Technical Bulletin

TB 0356 – Rectification of Loose Spring Charge Limit Switch – Reyrolle LMVP Series.

Date: 11/10/2024

Figure 1 Limit switch in operating mechanism.

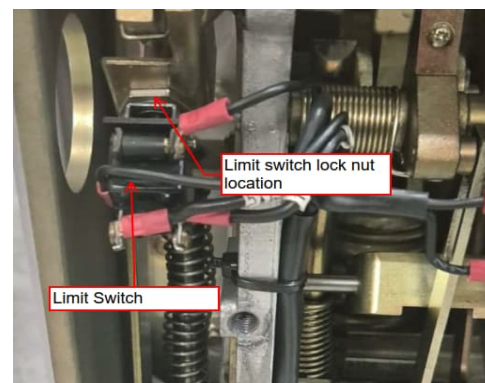
There has been an increase in the number of reported cases of the nut that secures the spring charge limit switch becoming loose in the mechanism of the Reyrolle LMVP series circuit breakers. This is usually picked up during minor overhaul activities and has also caused several functional failures.

The spring charge limit switch is used to disconnect the spring charge motor once the spring is fully charged. A loose limit switch may eventually result in damage to the motor and cause a malfunction in the trip/close operation of the circuit breaker.

Hardware securing the spring charge limit switches must be tightened as per OEM manuals after which they are to be secured with dual nuts. OEM manuals can be found through this link - [G:\Equipment Manual Library\South Manuals\switchgear](#).

It is a requirement that the securing hardware (nut) be checked for tightness during minor overhaul activities, and replaced, retightened and locked (as above) where necessary.
